Wednesday, November 2, 2022
PERMIT MODIFICATION APPROVAL
Horizontal 6A / New Drill

Re: Permit Modification Approval for 5H
47-103-03523-00-00

Cement Variance to include the use of Class A / Class L cement

Re: Class L Cement Variance Request
Cash 5H Well
Permit Number 47-103-03523
Center District, Wetzell County

Wellbore Diagram

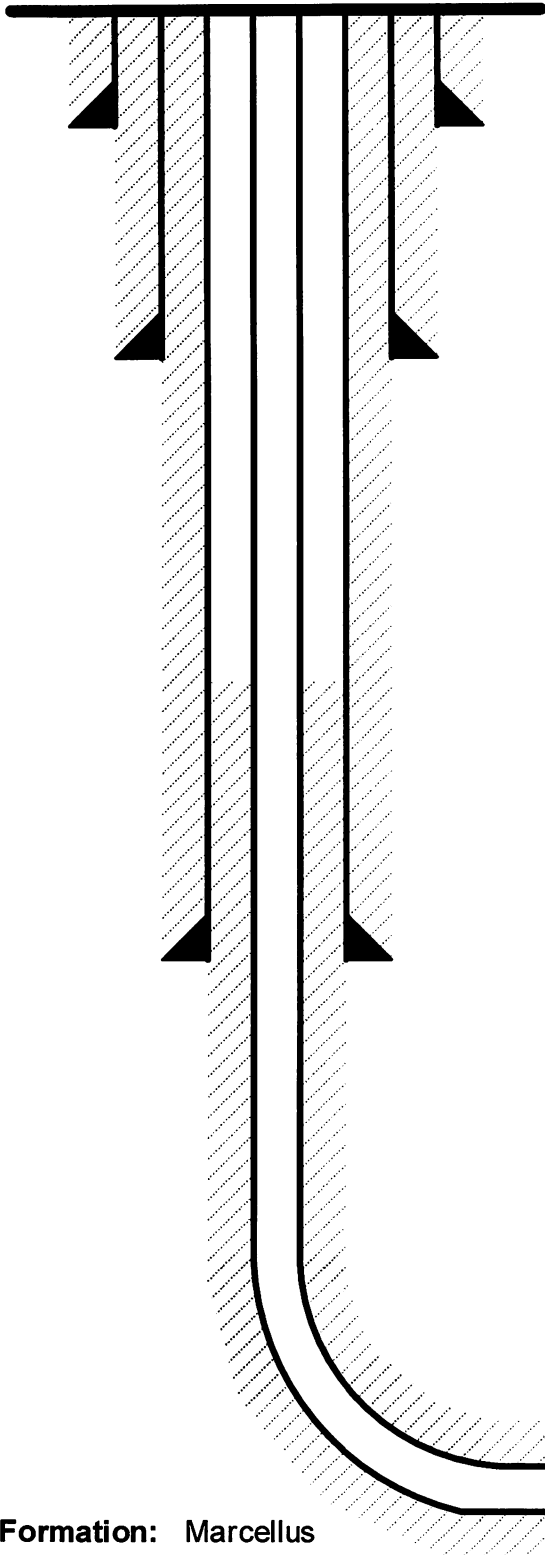
This modification is to add the potential use of Class L cement as an option for casing and cementing of this well.

26", 85.6#, A252 GR3, cement to surface w/ Class A/L

13-3/8", 54.5#, J-55, cement to surface w/ Class A/L

9-5/8", 36#, J-55, cement to surface w/ Class A/L

6", 24#, P-110, cement to 500' inside 9-5/8" w/ Class A/H/L
